Public Service Company of New Mexico  
Attn: Thomas Duane, Director of Integrated Resource Planning  
Re: Questions Related to Modeling Transmission & Markets in PNM's 2026 IRP

#### PNM 2026 IRP Transmission & Markets Questions

# Encompass Zonal Topology for PNM

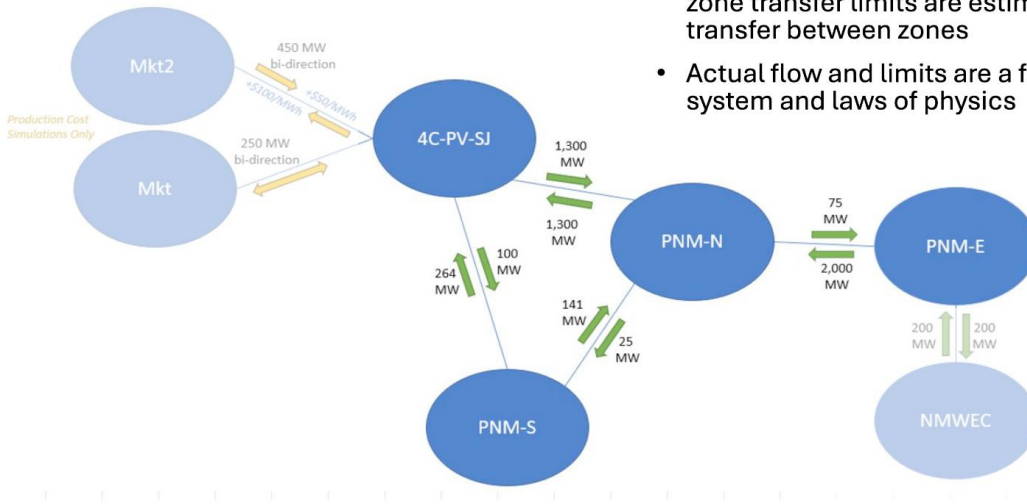
1. Is the diagram on slide 8 from PNM's Feb 17, 2026, IRP Transmission Modeling Office Hours an accurate representation of the zones and transfer limits in PNM's zonal LTCE model?
2. Do transfer limits change at future dates to account for PNM's planned transmission upgrades? If no, why not?
3. How do planned generator retirements impact transfer capability in the zonal model? For example, when PNM exits Four Corners in 2031, does the Encompass model increase transfer limits from 4C to PNM-N from 1,300 MW to 1,500 MW? (1,300 MW is the transfer limit shown in Slide 8 of the transmission presentation and the additional 200 MW were mentioned in a discussion about FCPP in the 2023 IRP)

12. Slide 8 from the Feb. 17, 2026, workshop shows market zones with transfer limits (Mkt 250 MW bi-directional; Mkt 2 450 MW bi-directional) and labels these with “Production cost simulation only.”

- a. What markets are Mkt and Mkt 2?
  - b. Are the transfer limits between PNM and market zones based on transmission system limits or assumptions about market depth or something else?

- c. What is meant by the labels “+\$100/MWh” and “+\$550/MWh” on the path from 4C-PV-SJ to Mkt2?]
13. Could you please explain how the addition of nodal PCM in this IRP interacts with or replaces zonal PCM as used in previous IRPs? Does Encompass still use a zonal model to calculate the production costs of each portfolio, or only for portfolios that aren’t run through the nodal PCM?
